DEPARTMENT OF COMMUNITY DEVELOPMENT SERVICES

TO: The Urbana Historic Preservation Commission

SUBJECT: HP 2008-COA-07, Certificate of Appropriateness for the Addition of a Three-Season Porch and New Basement Entrance at the rear of 807 W. Main St., a Contributing Building in a Historic District

907 W HW SITE PLAN

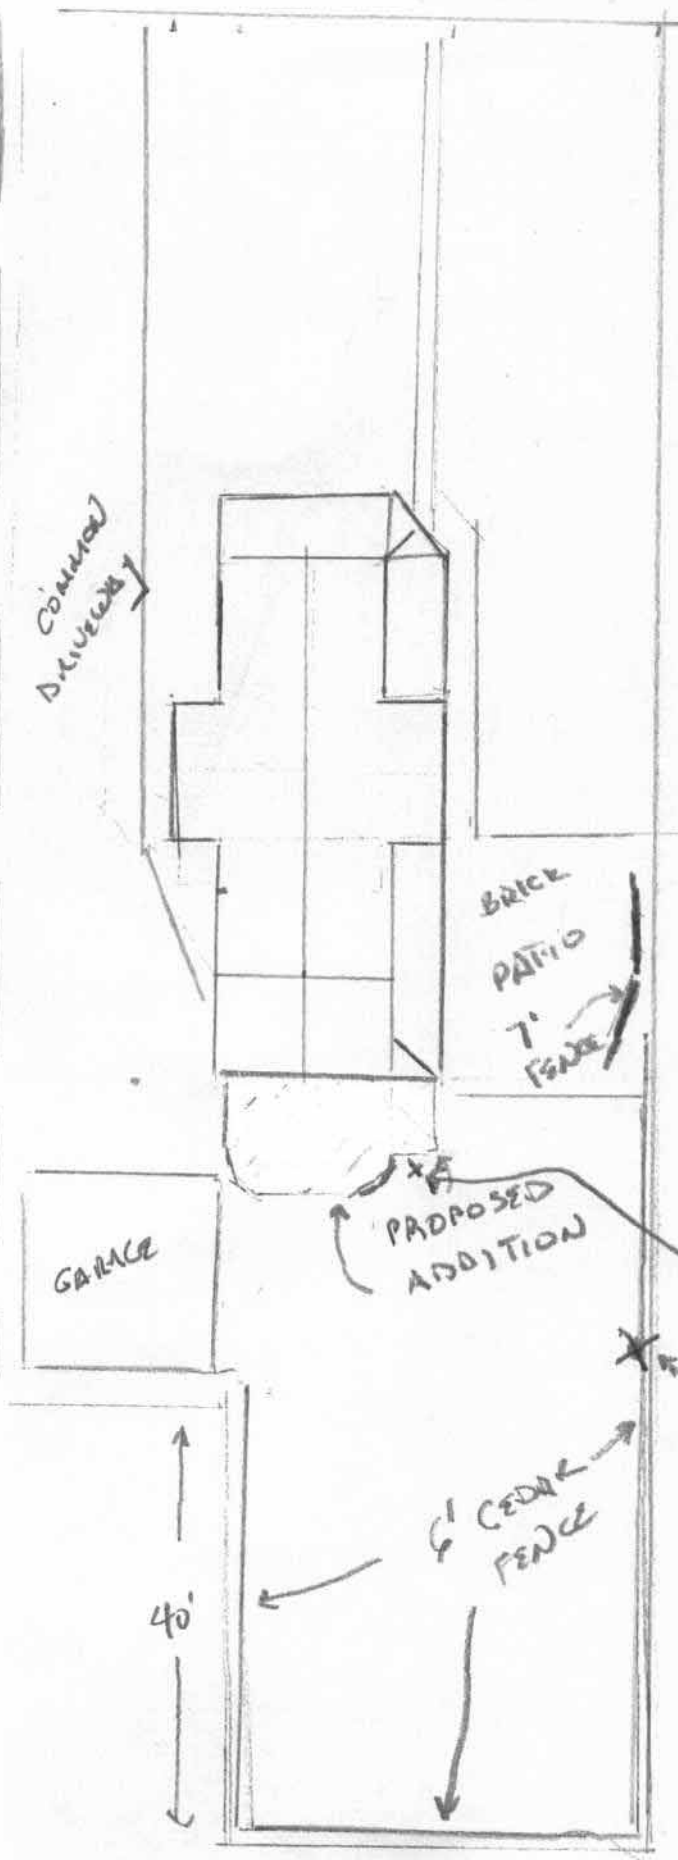
The proposed construction is limited to the rear (south) façade and will not be visible from the public right-of-way. Much of the south façade is not original. According to the 1923-1945 Sanborn Map, the southern most part of the house was only one story at that time and the southeast porch is not depicted. The upper part of the gable, including the French doors and the balcony, was added in 1992 and the basement entrance was added in the 1960s or 1970s. The only architectural features the proposed addition will affect are the existing kitchen window and the existing siding. The petitioner will side the new addition to match the rest of the house. Additionally, the porch will be constructed in such a manner that if it were to be removed in the future, the essential form and integrity of the building would remain unimpaired.

As the addition will only affect the rear façade which is not visible from the public right-of-way, City staff conclude the proposed work will have no impact on the historic value, characteristics or significance of the 800 Block of West Main Street Historic District.

807 W MAIN
ADDITION
FLOOR PLAN

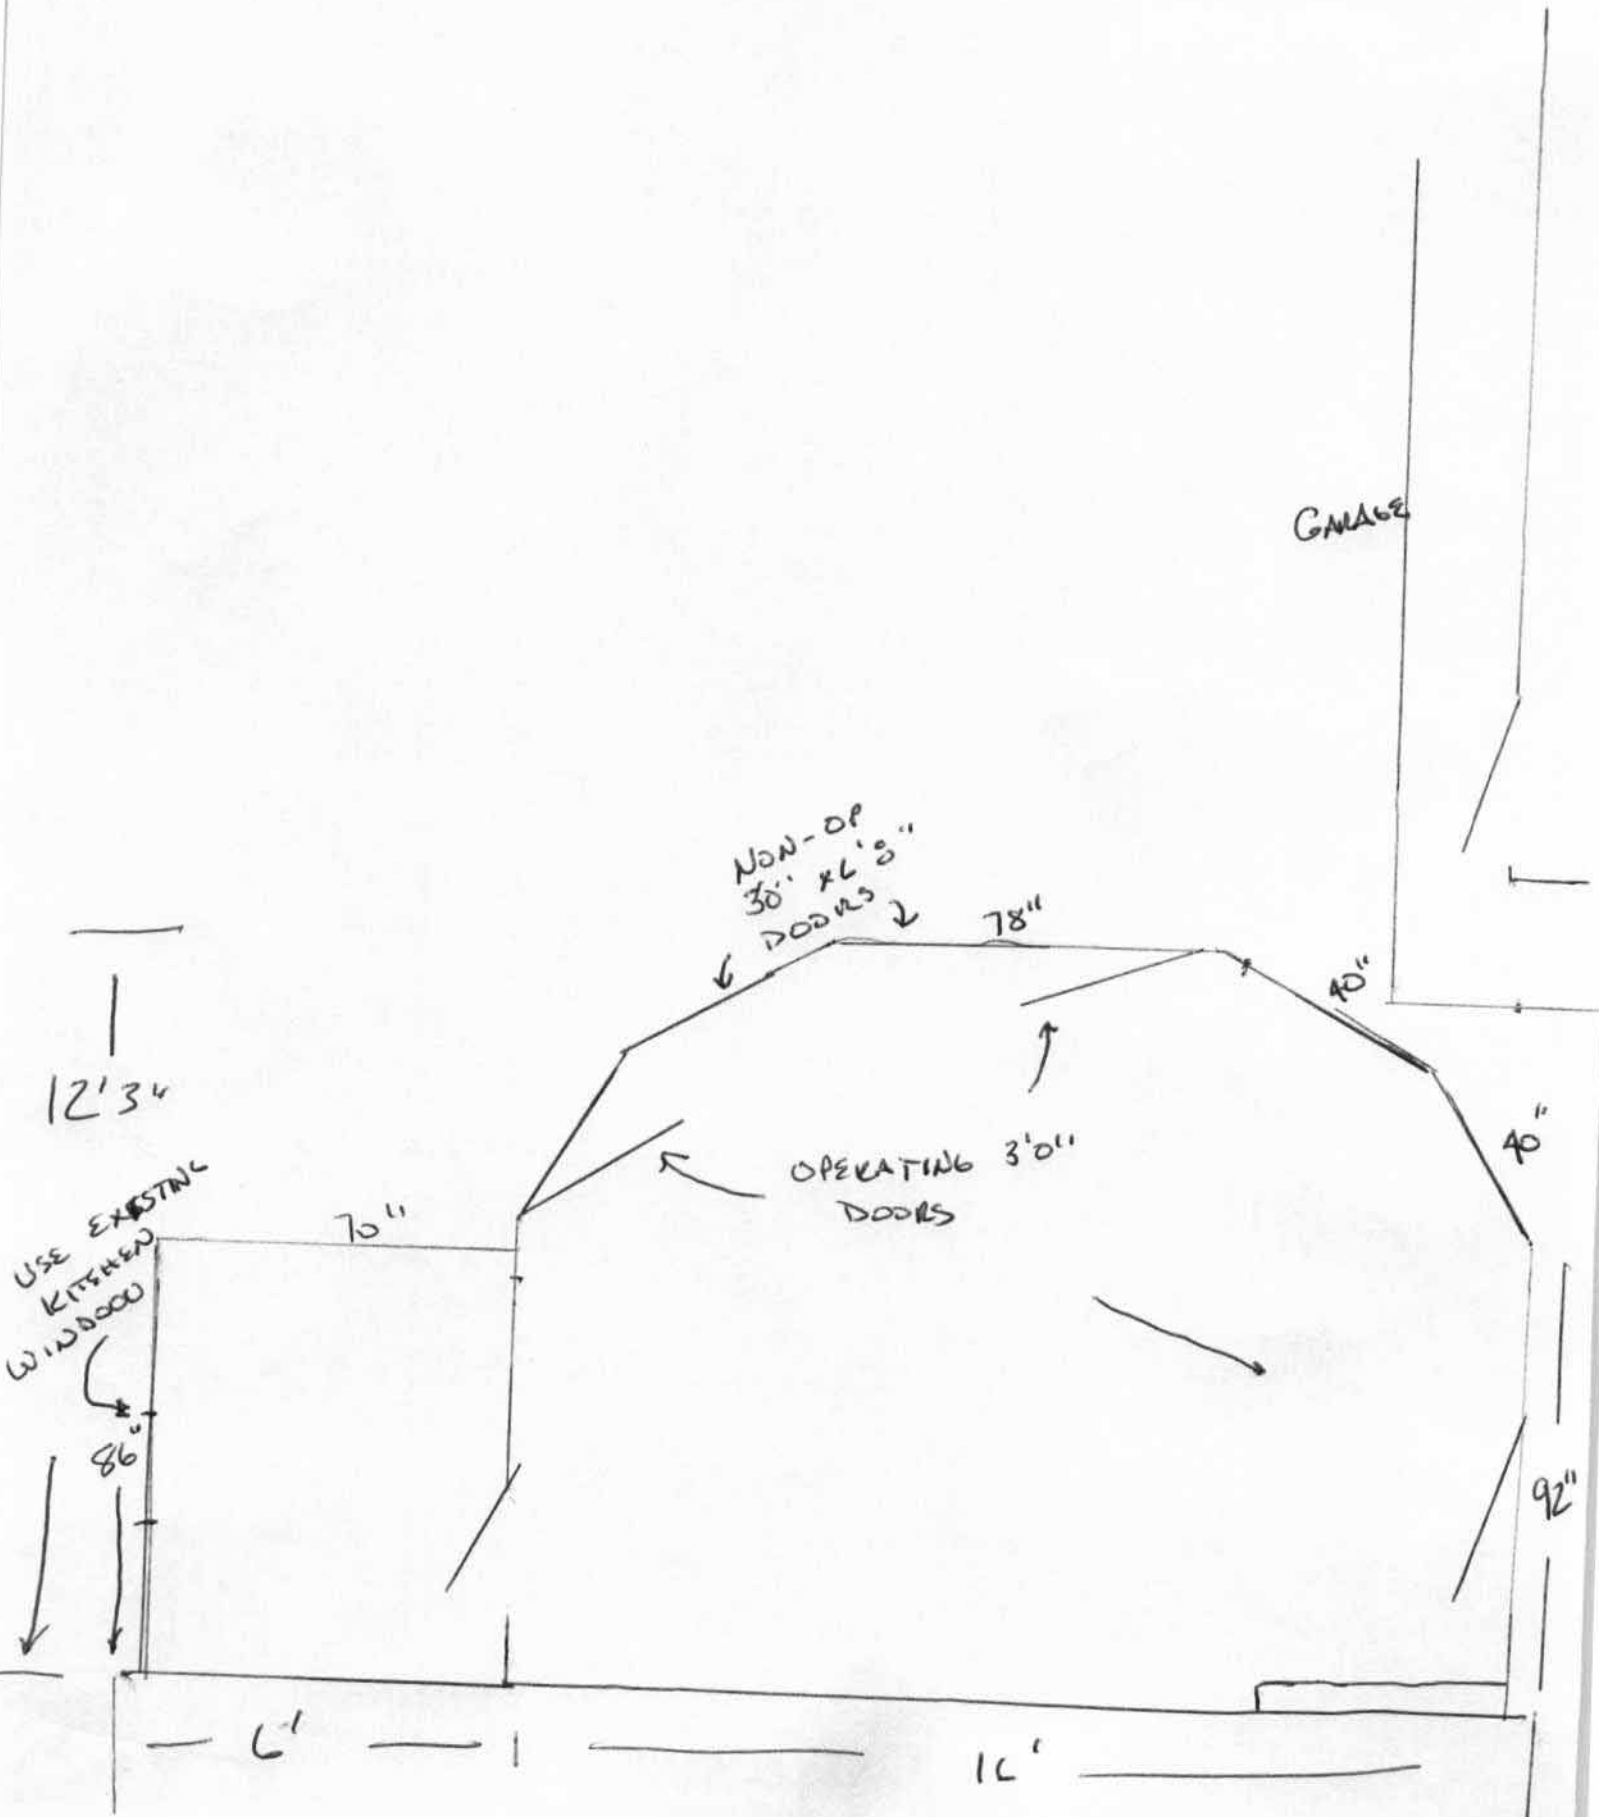
There are no significant original qualities on the south façade. The kitchen window and some of the cedar siding will be removed, but the addition will use appropriate-age salvaged windows and full-view 15 divided lite doors which will closely match the existing doors on the east elevation. The addition will be sided with like materials.

The proposed new addition will be one story. The house originally had a one-story wing on the rear façade. The proposed new addition will not affect the front façade of the house. The proportions of openings into the house will change on the rear façade. Currently there is only one window on the first story rear façade. The addition, a three-season porch, will have four 15-lite doors on the rear façade. The relationship between the house and the garage will be affected, but it will not be visible from the public right-of-way. The addition will bring the house much closer to the garage. The roof over the sunroom will have a hipped roof, similar to that on the existing east porch. The compatibility of the existing house to the district in terms of scale and the directional expression of the front elevation will not be affected as the proposed addition will not be visible from the public right-of-way.

City staff conclude that the proposed new addition will be compatible with the original architecture of the house.
